AMENDMENT OF SOLICITATION/MODIFICATION OF CONTRACT				1. CONTRACT ID CODE		PAGE OF PAGES		
2. AMENDMENT/MODIFICATION NO.			3. EFFECTIVE DATE		4. REQUISITION/PURCHASE REQ. NO.		5. PROJECT NO. (If applicable)

1. The specifications and drawings for Invitation No. DACW64-02-B-0012, Redfish Island Restoration, (45-Foot Project), Houston-Galveston Navigation Channels, Texas, advertised 17 January 2002, and for which bids are to be opened on 20 February 2002, are hereby modified as follows:

**TYP BREAKWATER OPTION SECTION
STATION 37+50.00 TO 40+22.38**

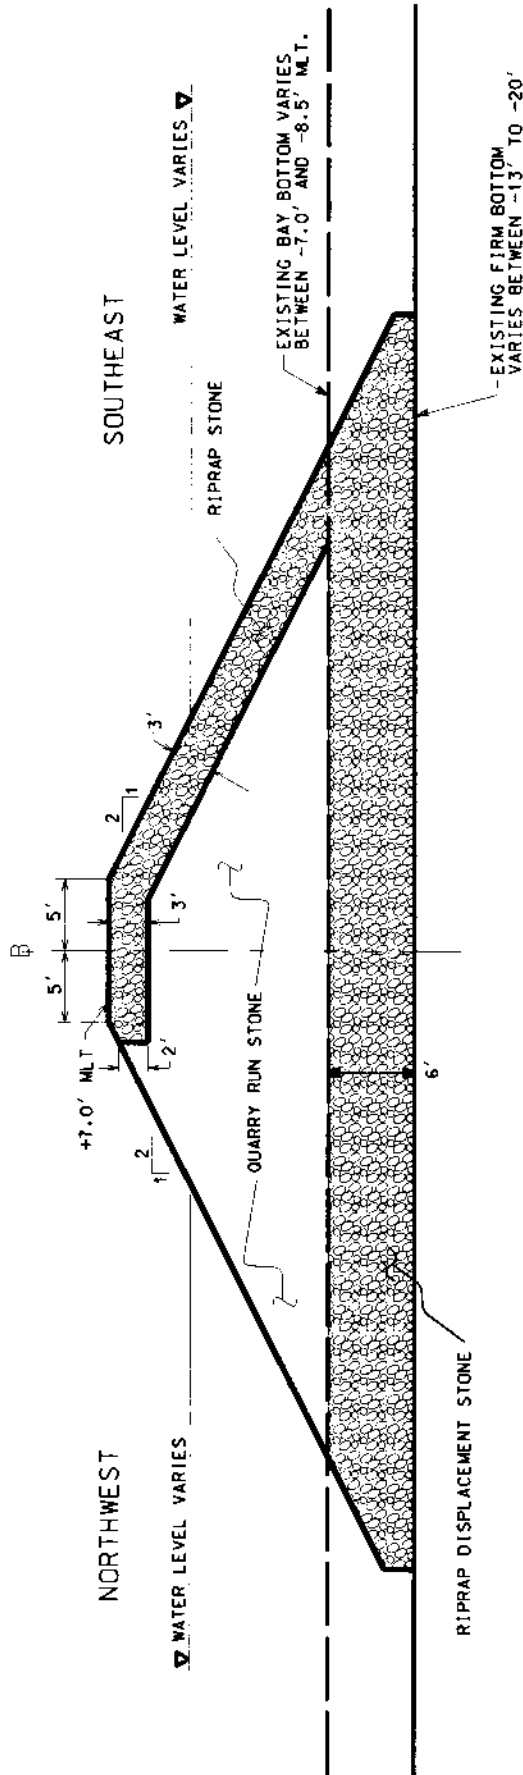
(4) Drawing No. C-12. - The enclosed FIGURE 1 shall be added to this Drawing No. 12 and become part of this Invitation.

1. BOTTOM LAYER OF RIPRAP DISPLACEMENT STONE TO BE 6' THICK. BOTTOM ELEVATION OF LAYER TO BE DETERMINED IN FIELD AS DEPTH THAT RIPRAP DISPLACES EXISTING MATERIAL.
2. BOTTOM OF QUARRY RUN STONE TO BE TOP OF 6' THICK LAYER OF RIPRAP DISPLACEMENT STONE.

TO BE ADDED TO DRAWING NO.C-12.
